SIB 84 05 25

2025-08-13

## REPLACEMENT TELEMATICS MODULE CANNOT BE PROGRAMMED BY ISTA

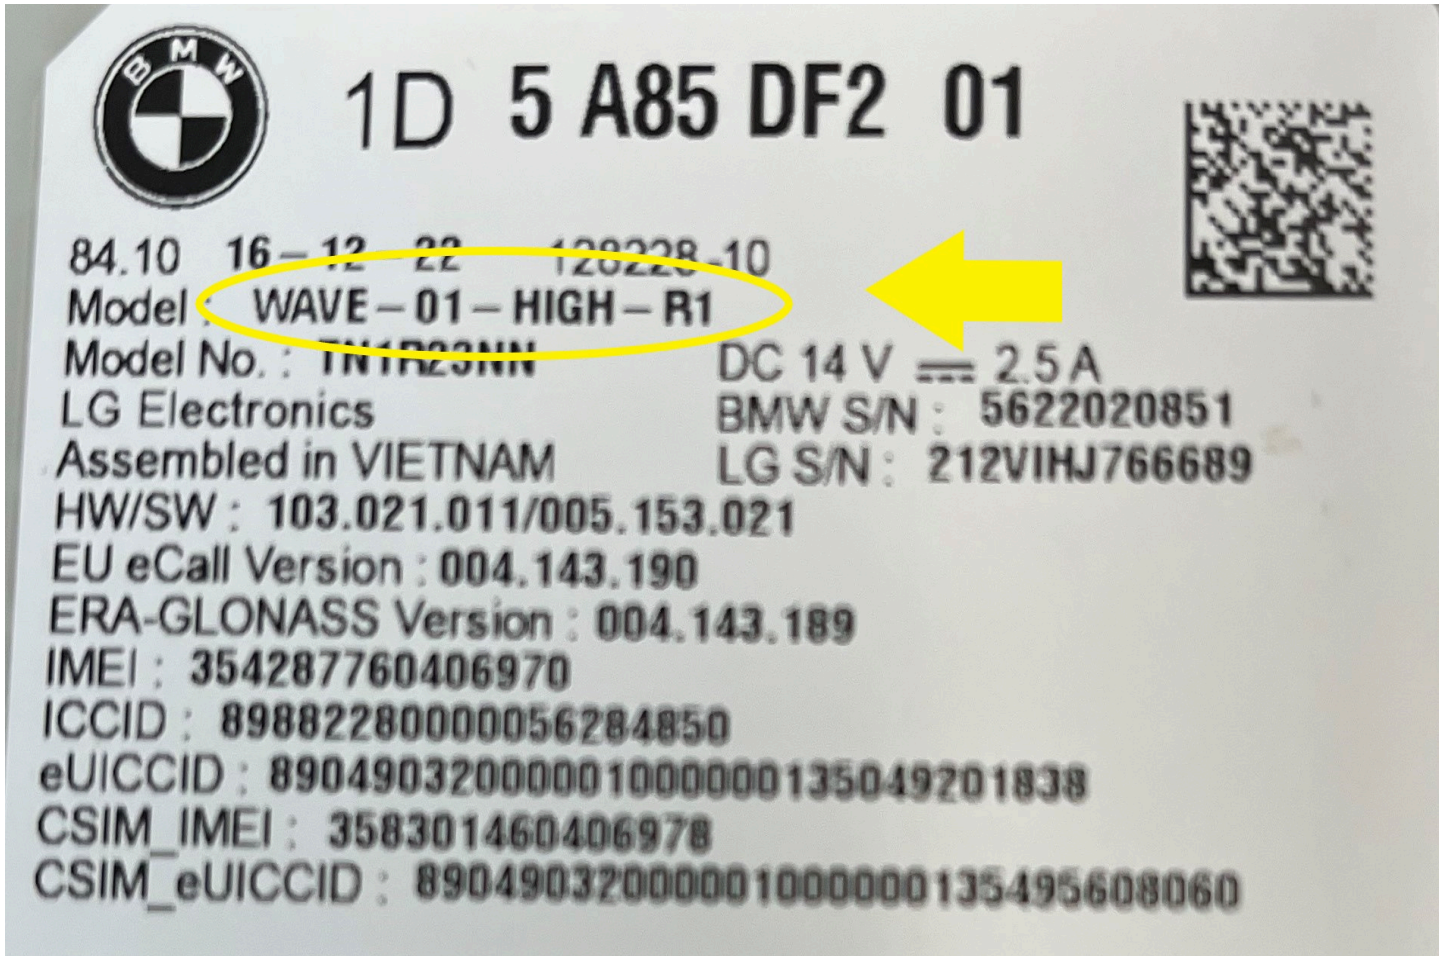
After the telematics module (TCB4) has been replaced, the replacement part control unit is not accepted by ISTA.

### CAUSE

The replacement telematics module (TCB4) is built by a different supplier.

The TCB4 replacement parts are changing supplier versions from WAVE-11 High to WAVE-01 High. This change in hardware will not be accepted in ISTA when performing programming for replacement.

Perform an ISTA conversion to add the K-word “ERWA” to the Vehicle Order. This will alter the TCB4 coding.

For ISTA to accept the hardware change from WAVE-11 to WAVE-01, the programming conversion “Replacement of WAVE11 to WAVE01” will need to be performed AND the vehicle will need to be programmed to I-level ...25-07-500 or higher.
